## SERVICE INFORMATION NO. SI 36-118

Rotax Service Bulletin No. SB-912-073 and SB-914-055

# SERVICE BULLETIN

## Replacement of circlip (carburetor) for ROTAX® Engine Type 912 and 914 (Series)

Fig. 5

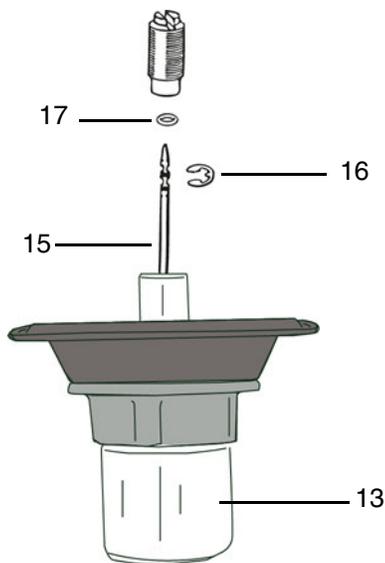
Step	Procedure
6	Remove jet needle (15) with circlip and O-ring from piston assy. (13).
7	Remove original O-ring (17) and circlip (16) from the jet needle (15) and discard. NOTE: Take note of the circlip's original needle position.

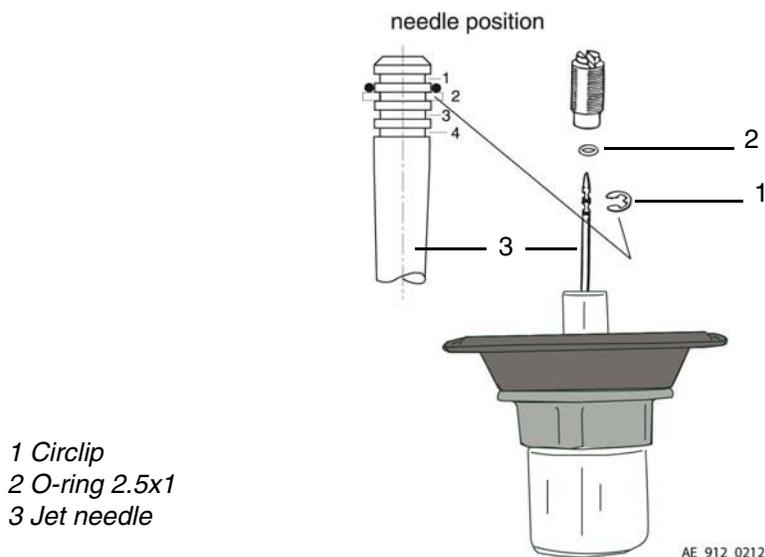
Step	Procedure
1	Place a new circlip part no. 945786 (1) into the same needle position. Place a new O-ring 2.5x1 part no. 950430 (2) over the jet needle (3).

Fig. 7

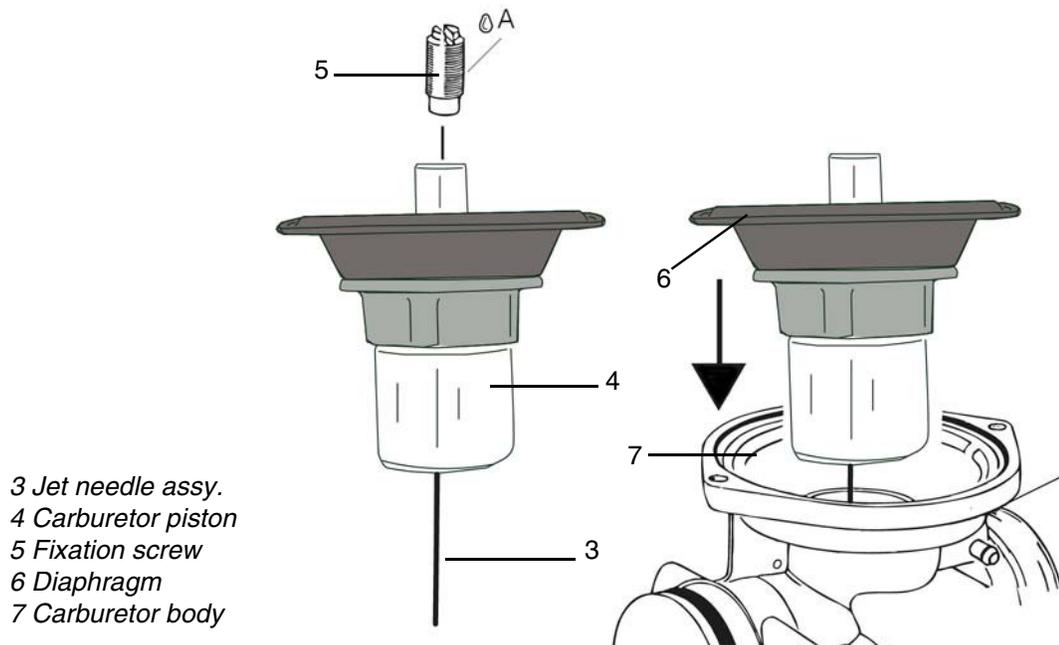
Step	Procedure
2	Place the jet needle assy. (3) into the carburetor piston (4) so that the needle protrudes through the piston.
3	Fix the fixation screw (5) with a small amount of LOCTITE 243 and tighten in place. NOTE: The jet needle is held in position by the circlip and its movement is damped by the O-ring.
4	Place the piston assy. (4) into the carburetor body. The diaphragm's alignment tab (6) must be seated within the carburetor body recess (7).
